TECHNICAL BULLETIN

Poor Starting and Running – XJR-S – Twin Coil Modification

18-54

MODEL 1993 MY XJR-S (6.0L)

ILLUSTRATION 1

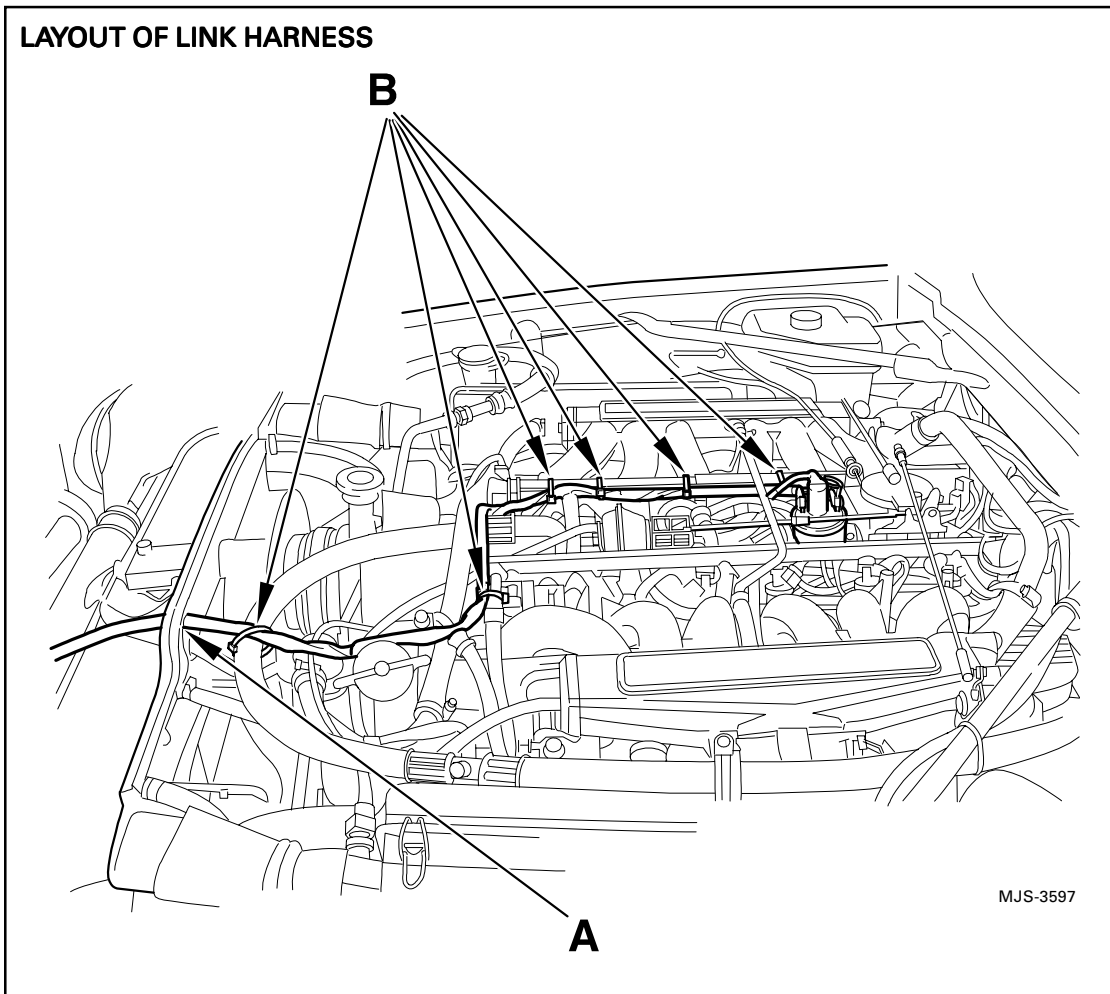
16. Lay the link harness to follow the route shown in Illustration 1 and then through the grommet at A in Illustration 1, in the top radiator cross member.
17. Fit the link harness through the 19mm. hole in the auxiliary coil protective boot.
18. Connect the link lead terminals to the appropriate terminals on the auxiliary coil.
19. Recheck the connections and then place the boot in position on the auxiliary coil.

ILLUSTRATION 2

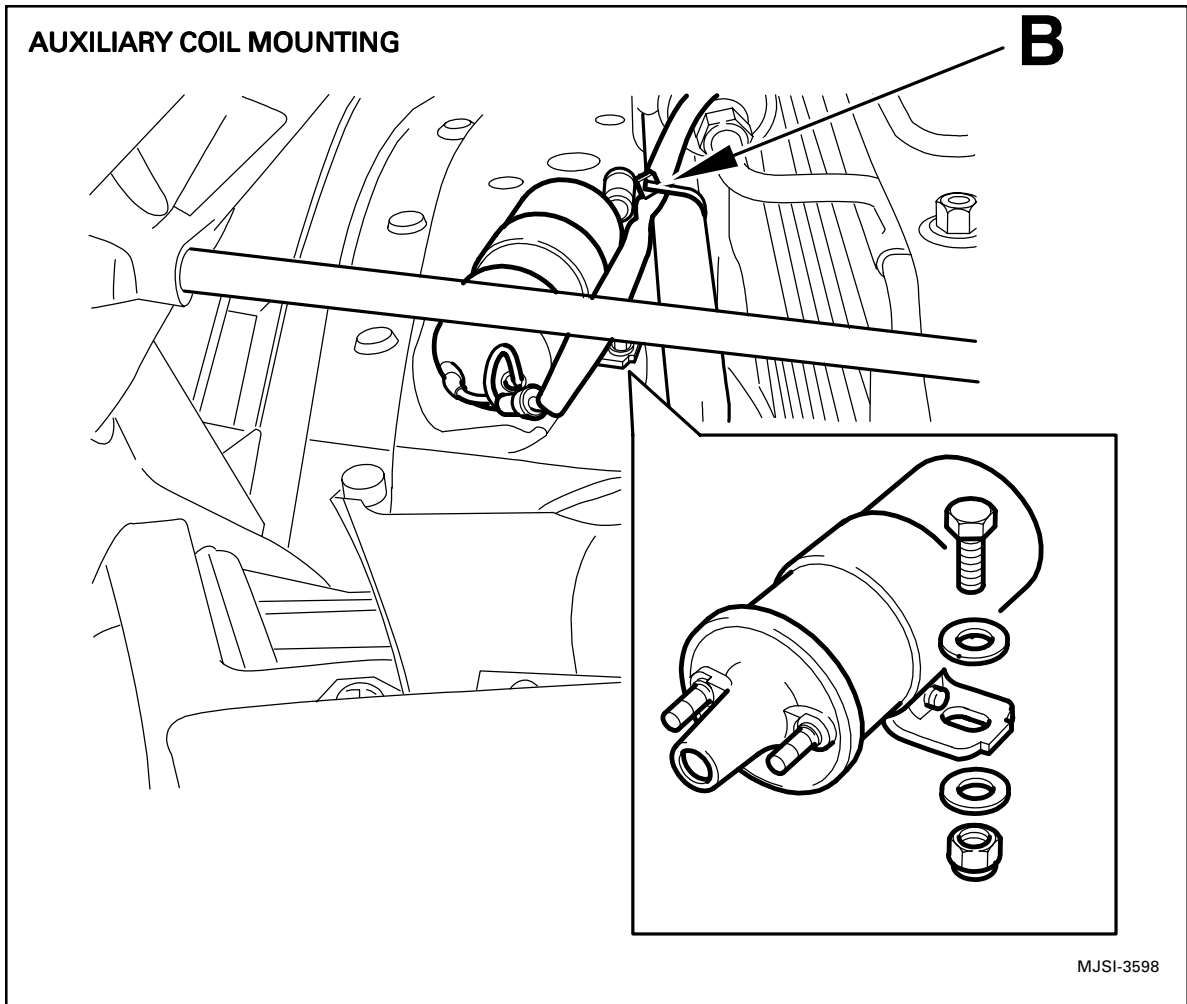
20. Install the auxiliary coil on the existing mounting points on the lower radiator cross member, as shown in Illustration 2.
21. Install plastic ratchet tie straps to the points indicated at B in Illustrations 1 and 2.
22. Do not over tighten the straps and remove all surplus lengths.
23. Remove the protective wing covers and close the hood.
24. Reconnect the battery, reinstall the battery cover and then close the luggage compartment.
25. Reset the clock.
